**ALLEGHENY COUNTY SANITARY AUTHORITY**

**CONTRACT NO. 1735 G, E, H, P**

**ALCOSAN PARKING GARAGE**

**ADDENDUM NO. 2**

1 LIFE SAFETY PLAN - GROUND LEVEL  
G-06 SCALE: 1" = 20'-0"

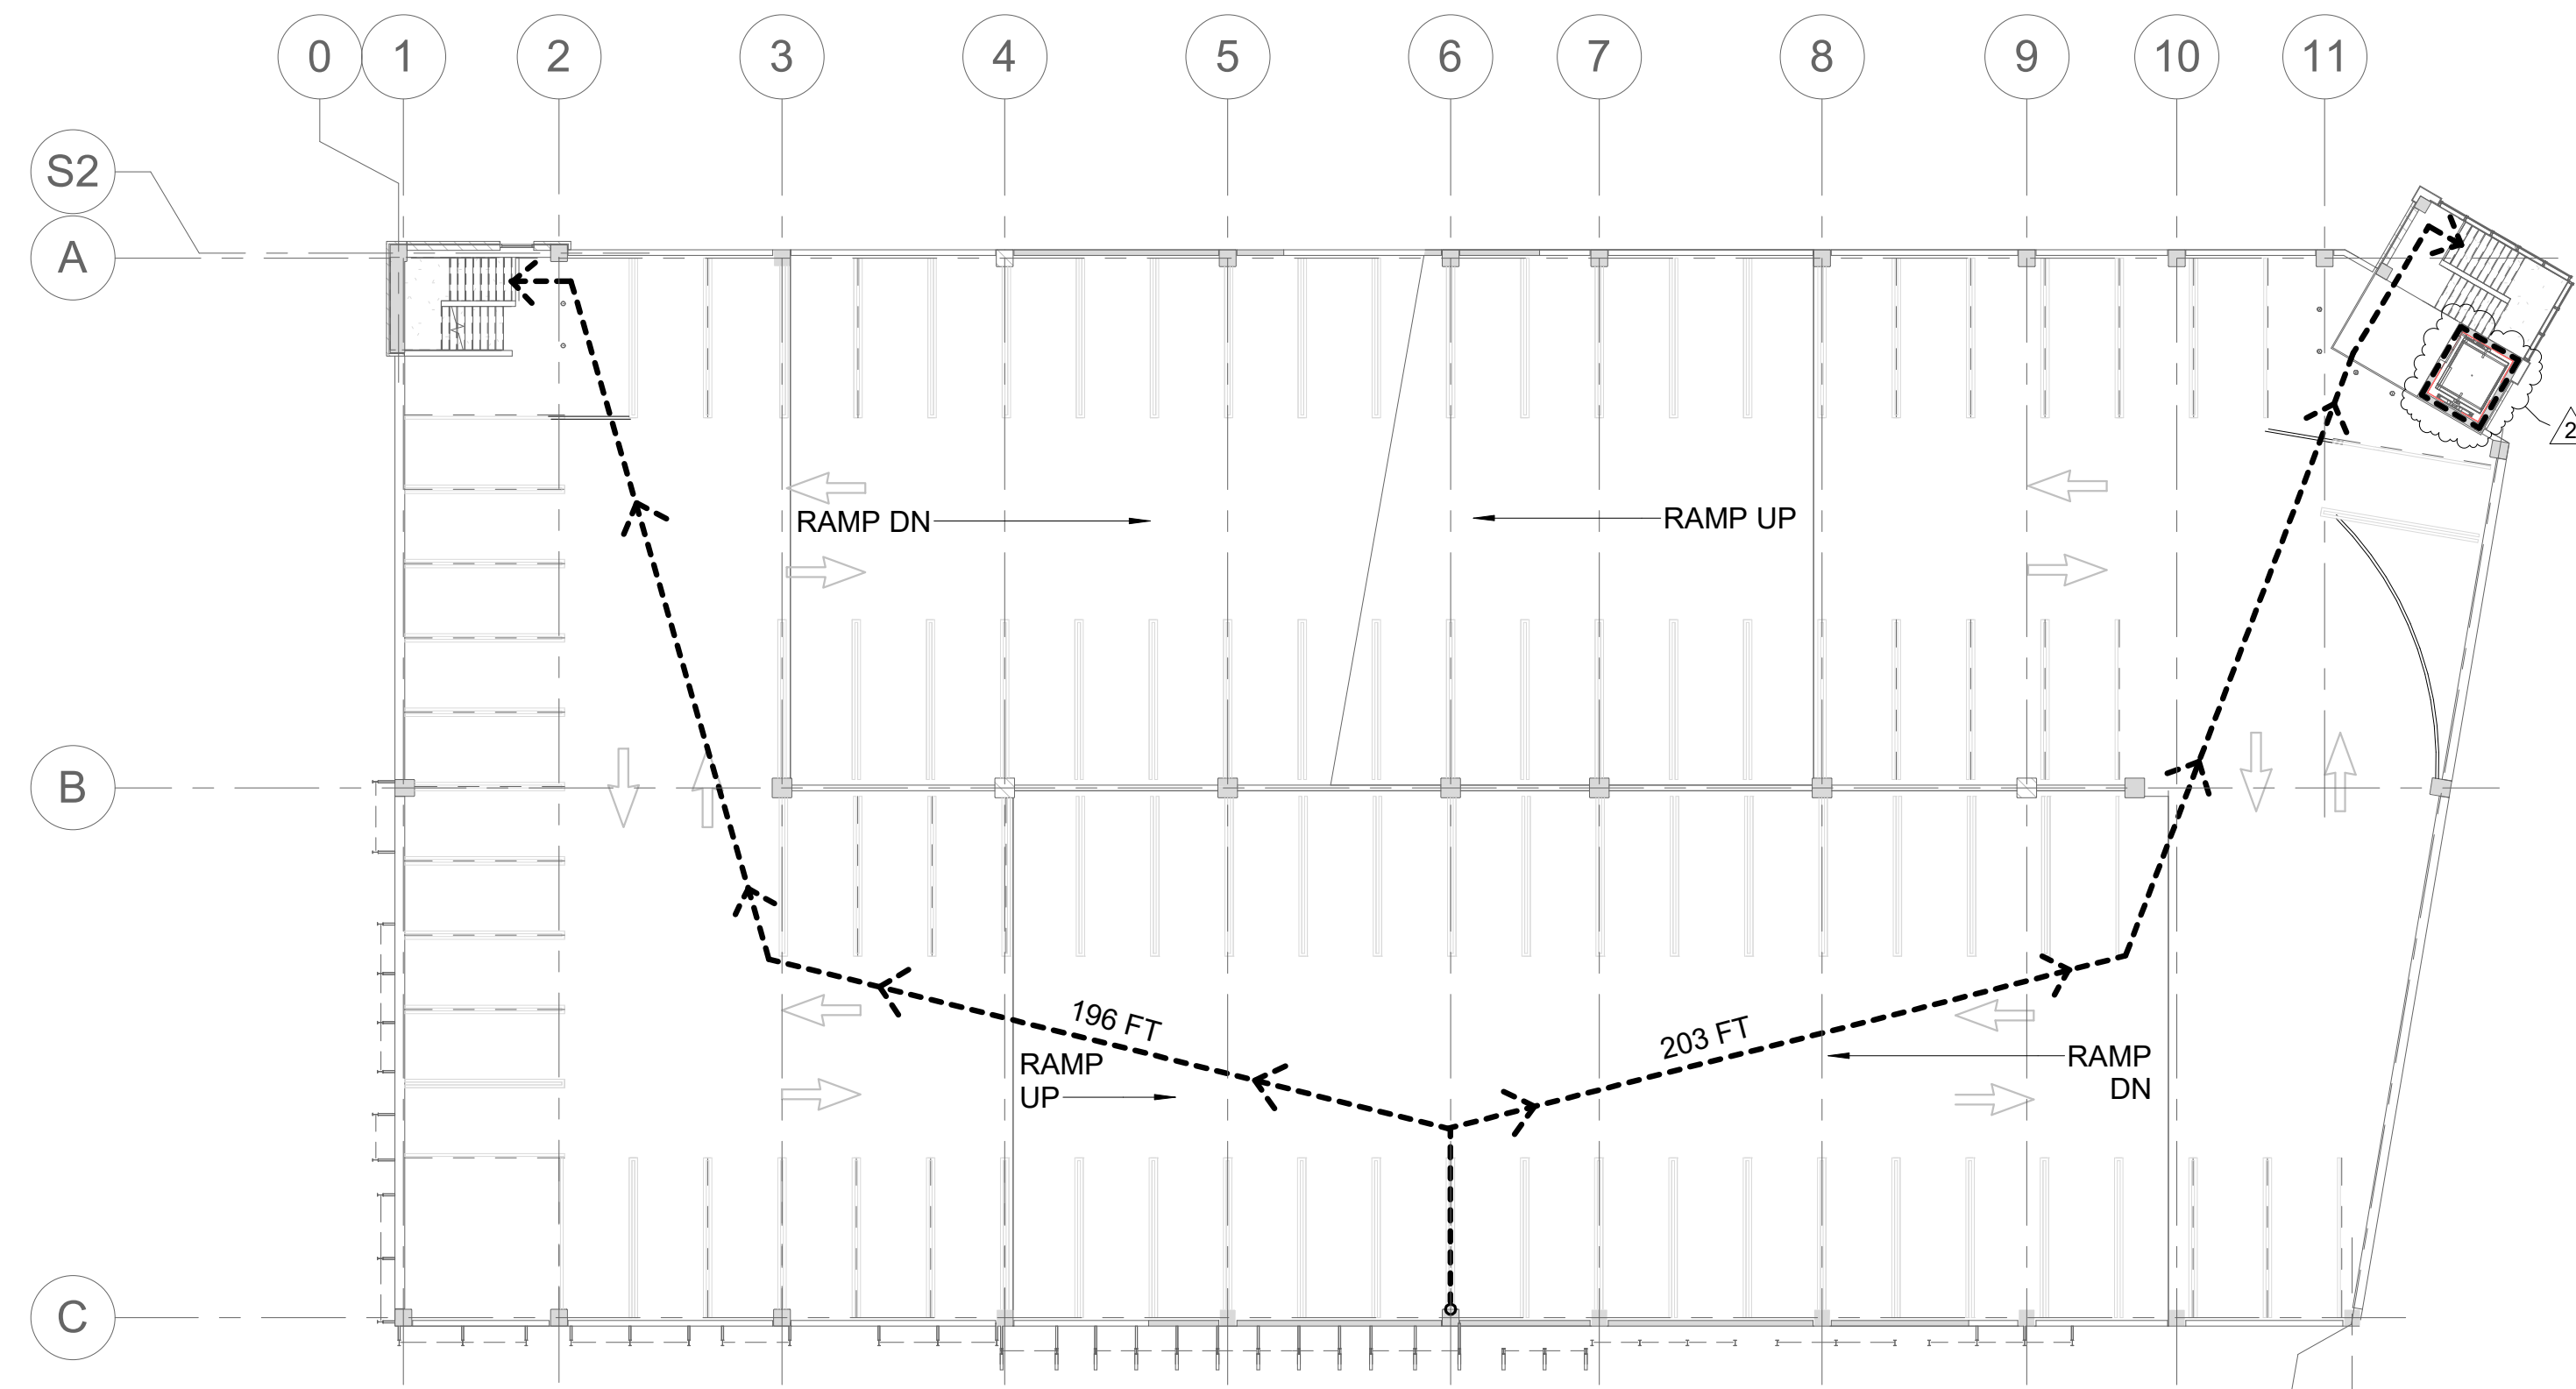
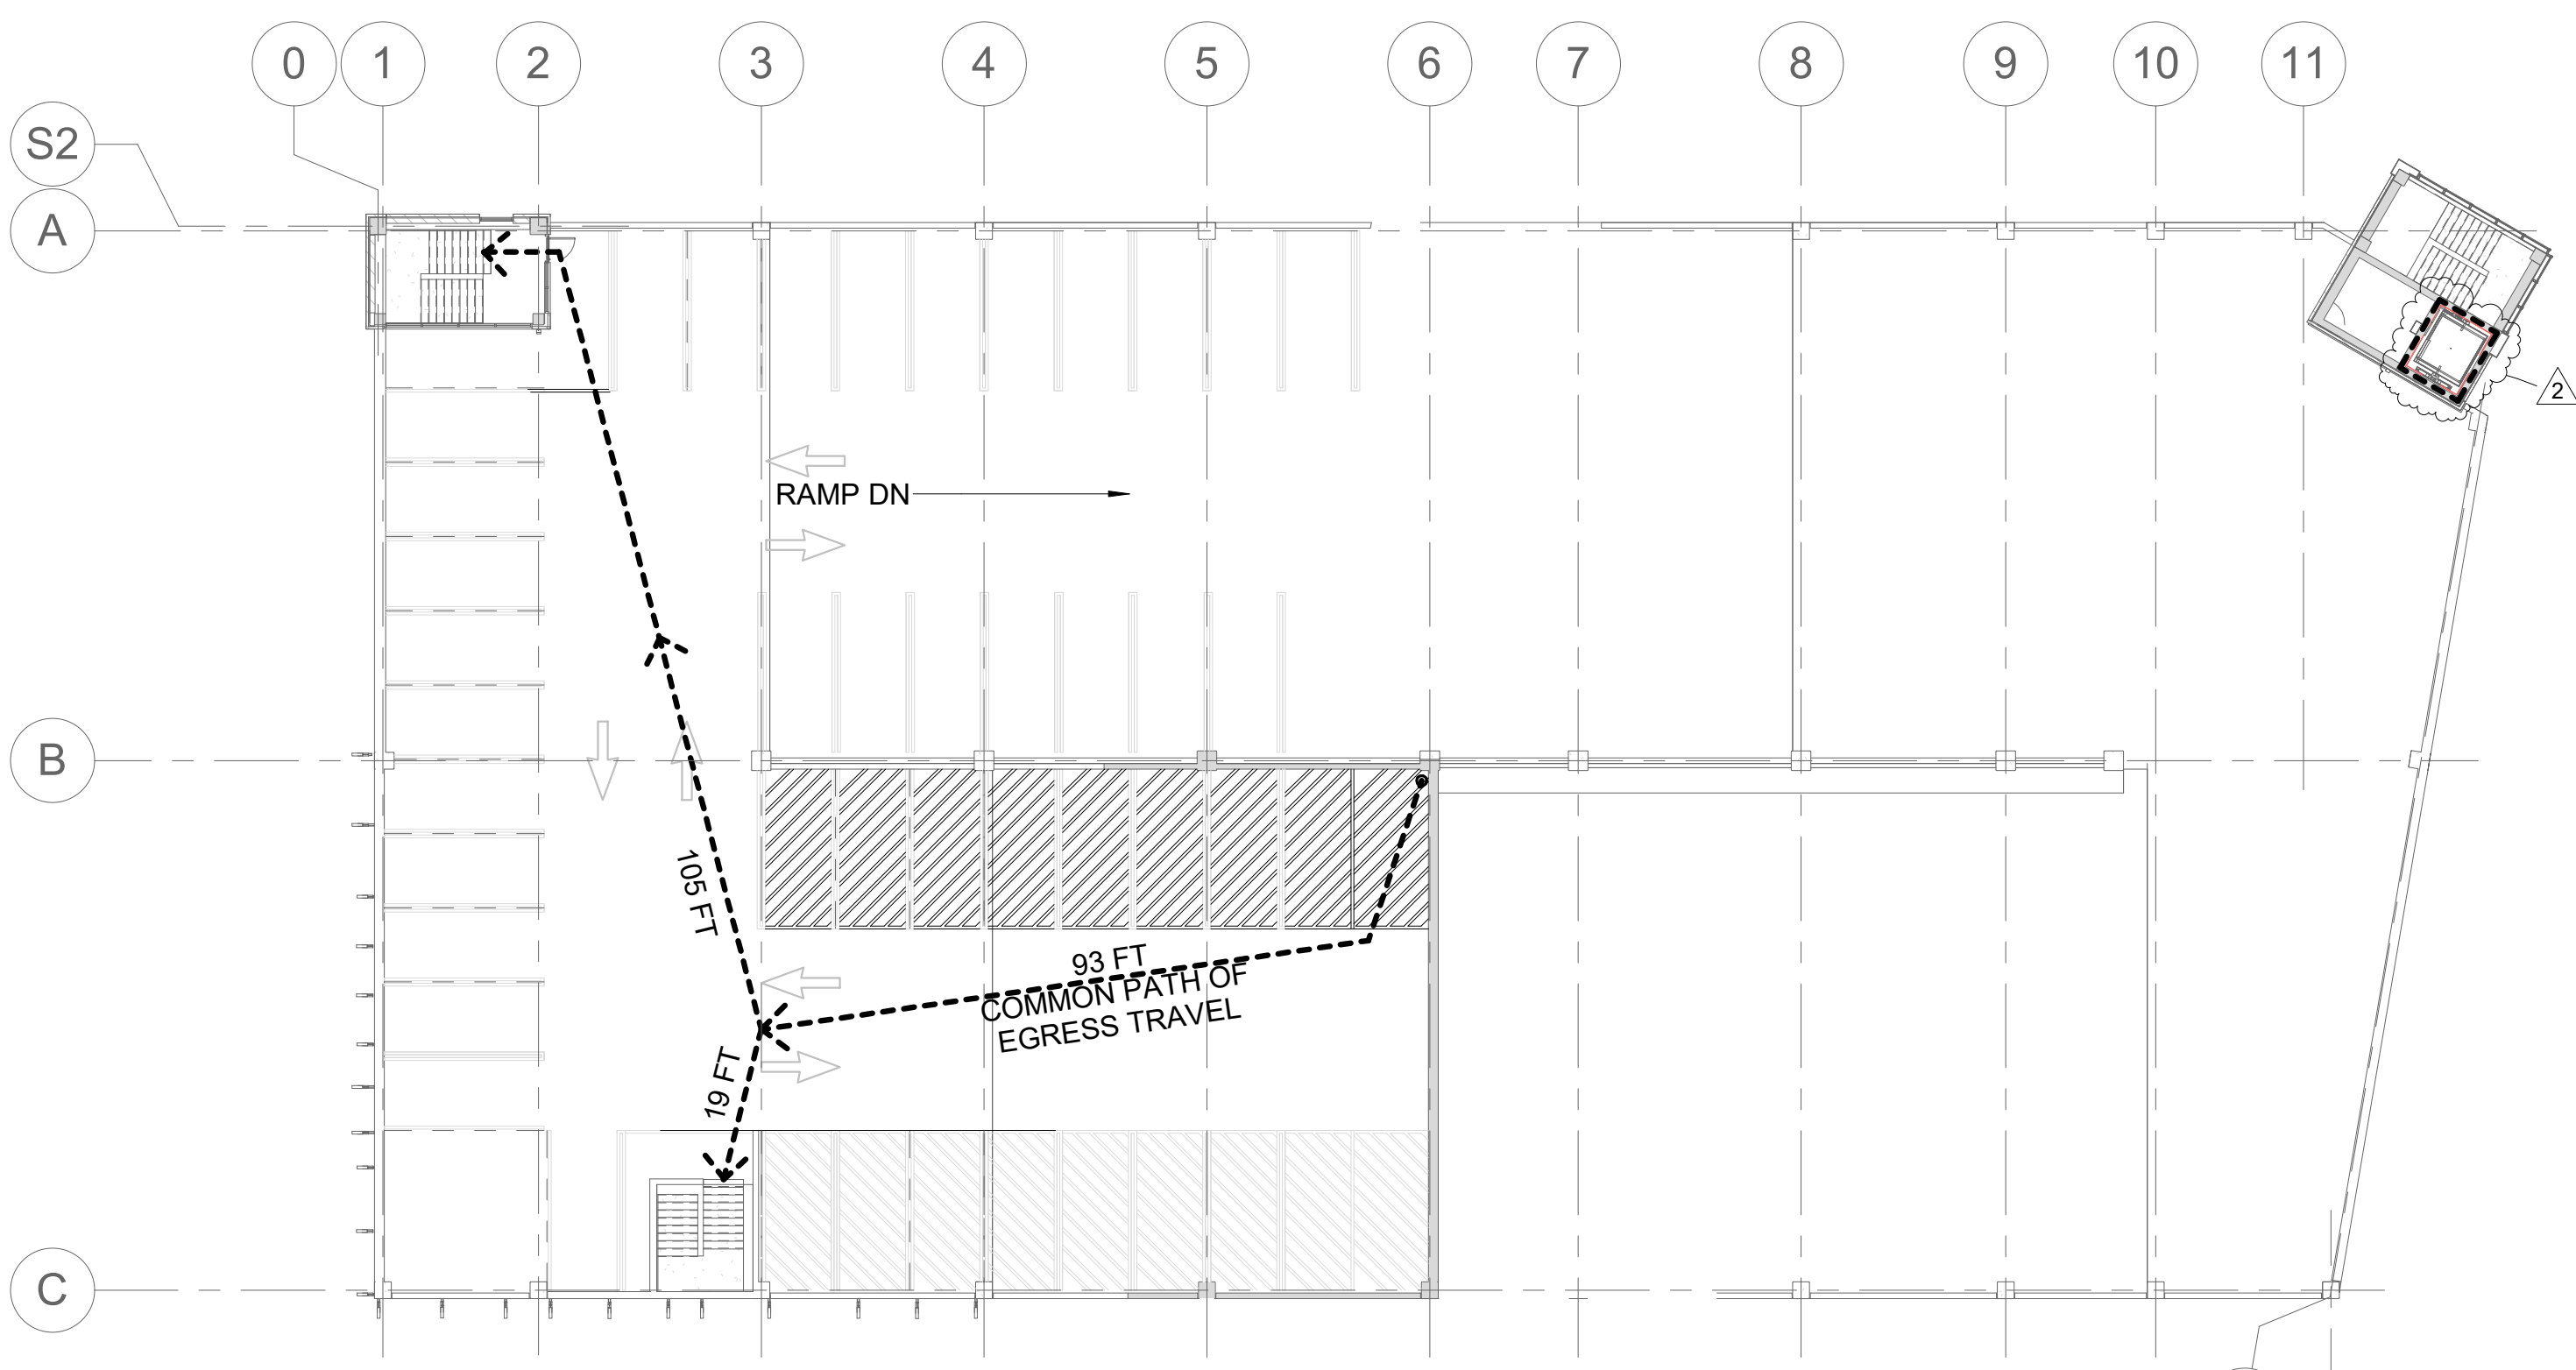
2. Drawing 210-G-06 - Life Safety Plans
  - a. REPLACE with the attached drawing 210-G-06
  - b. Extent of 2 hour fire rating clarified.

1 LEVEL 2 PLAN  
 A-11 SCALE: 3/32" = 1'-0"

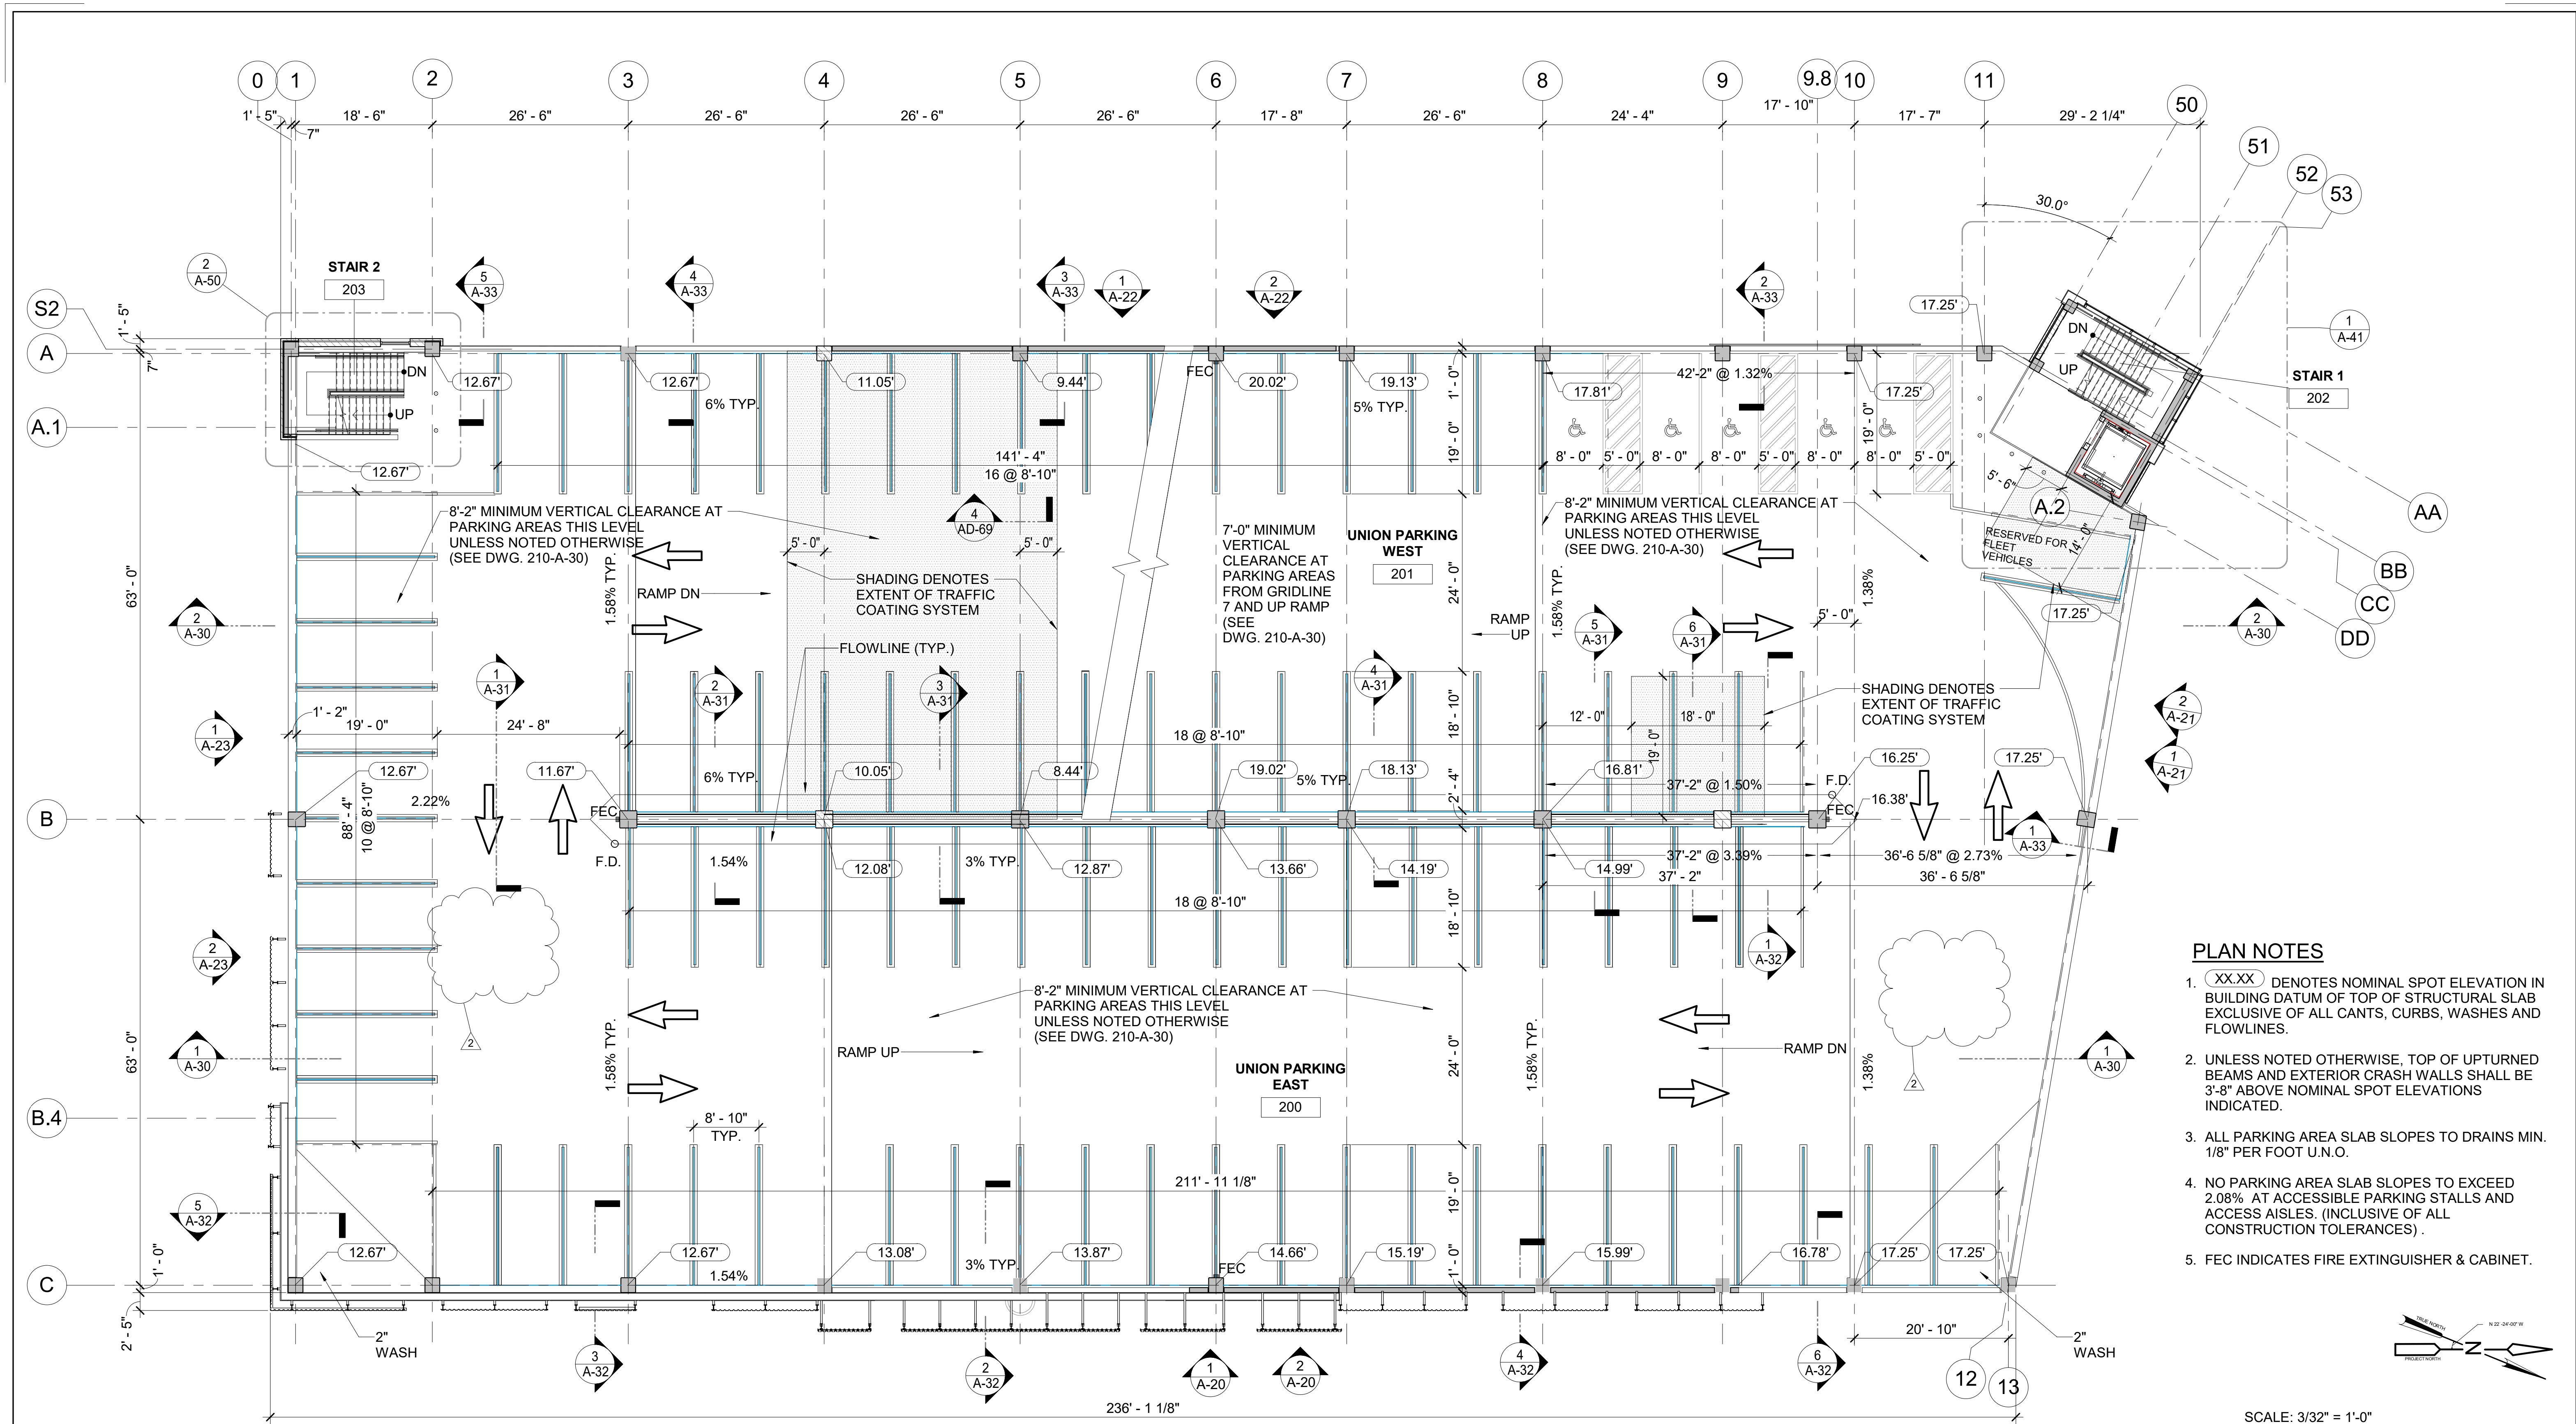
- c. Railing notes added in room 105.
7. Drawing 210-A-11 - Level 2 Plan
  - a. REPLACE with the attached drawing 210-A-11.
  - b. Call for assistance stations are deleted at columns B/3 and B/9.8.
